SB-GA8-2019-194

Service Bulletin

Deactivation or removal of 2 x 12V battery system from aircraft modified by SB-GA8-2017-176.

Figure 1

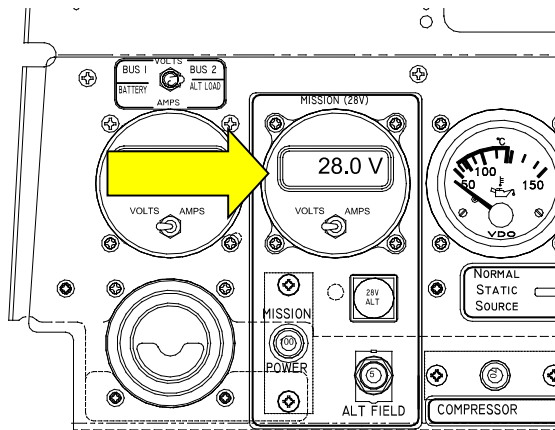
9. Observe the volt meter (Figure 1) over a range of RPM between 850 and 2500. Confirm that a stable 28V indication is present and that neither the ref or amber LED on the meter is illuminated.
10. Move the MISSION switch to the OFF position
11. Confirm the voltmeter reads battery voltage (nominally 24V).
12. Switch off the 24V battery source.
13. Shut down the aircraft engine.

Figure 2: Installed batteries (GA8-TC 320)

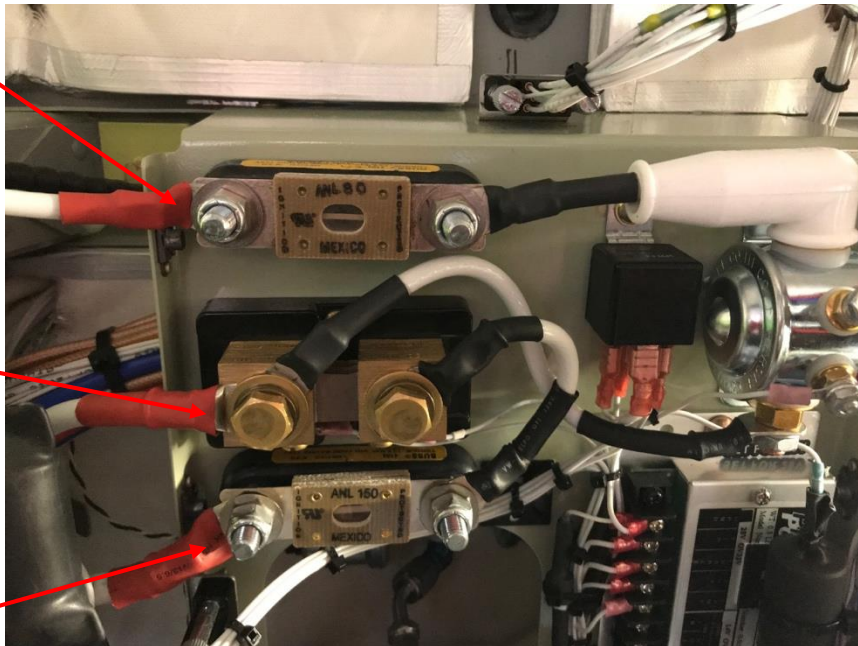
- 1.2.1 Pull the 70A circuit breaker attached to the positive side of the 2 x 12V batteries. (Refer to Figure 2).
- 1.2.2 Secure a cable tie around the shaft of the 70A circuit breaker in OFF or pulled position.
- 1.2.3 Secure the previously removed engine cowls to the aircraft.

- 1.3.1 Pull the 70A circuit breaker attached to the positive side of the 2 x 12V batteries (Refer to Figure 2).
- 1.3.2 Disconnect and remove the negative battery lead - 2PB001B6N from both ends.
- 1.3.3 Disconnect and remove the positive battery lead to the 70A circuit breaker from both ends.
- 1.3.4 Disconnect the link wire between the two batteries.
- 1.3.5 Remove both batteries from the aircraft.
- 1.3.6 Secure a cable tie around the shaft of the 70A circuit breaker in OFF or pulled position.
- 1.3.7 Secure the previously removed engine cowls to the aircraft.

- 1.4.1 Disconnect the 24V mission battery (non-factory) from the system.
- 1.4.2 Pull the 70A circuit breaker attached to the positive side of the 2 x 12V batteries (Refer to Figure 2)

Figure 3 : View showing power wire attachment to Mission Power Control Unit.

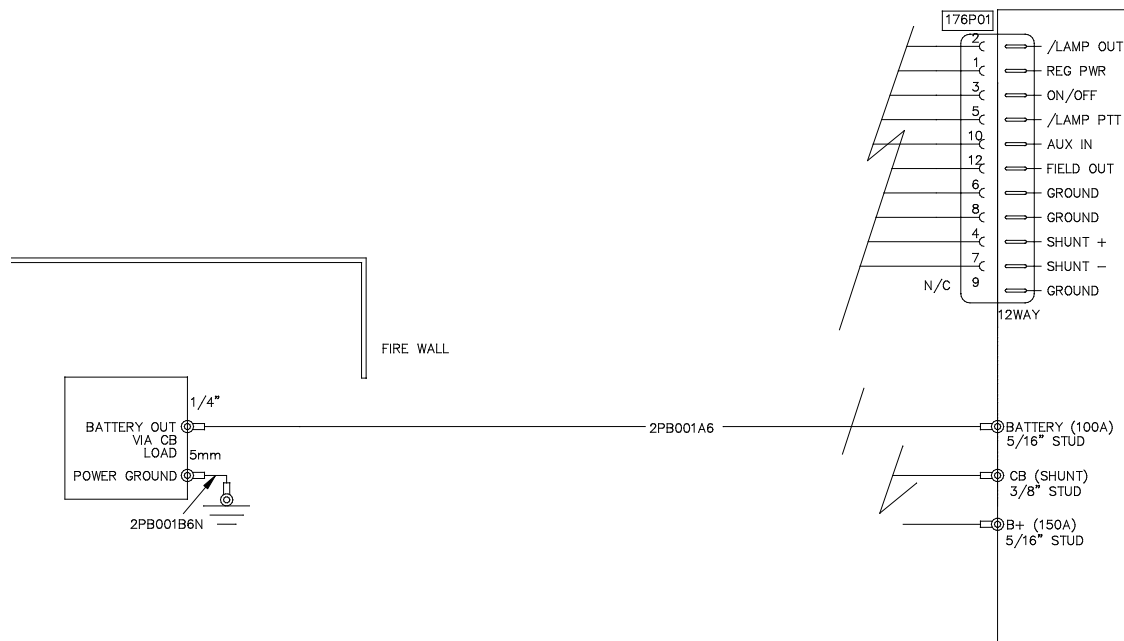
- 1.4.5 Disconnect the link wire between the two batteries and discard.
- 1.4.6 Remove both batteries from the aircraft.
- 1.4.7 Disconnect and remove the positive lead 2PB001A6 between the 70A circuit breaker and the Mission Power Control Unit (Refer to Figure 3). The Mission Power Control Unit is located on the aft side of the firewall, immediately behind the flight instrument panel.

Figure 5 – Partial view of electrical overhead panel.

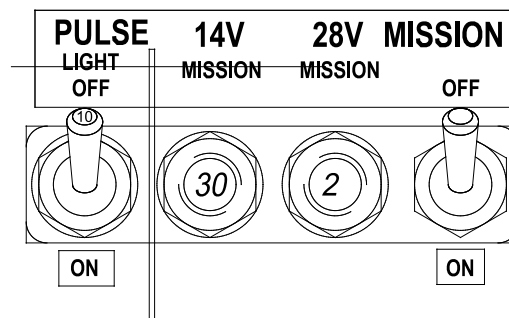
1. The “MISSION” switch located in the electrical overhead shall be in the OFF position.
2. The 2A “28V MISSION” circuit breaker is to be pushed in.
3. The 5A “ALT FIELD” circuit breaker shall be pushed in.
4. The 100A “MISSION” circuit breaker shall be pushed in.
5. Start the aircraft engine.
6. If an alternate 24V battery is installed, enable the 24V source to the aircraft i.e 24V Batt switch located in the aircraft overhead panel.
7. Verify 24V battery voltage is displayed on the 28V Mission voltmeter. Ensure the voltage is 24V or above.
8. With the engine running and when advised as safe to do so by the pilot or taxi endorsed operator, place the 28V switch “MISSION” to the ON position (see Figure 5 below).
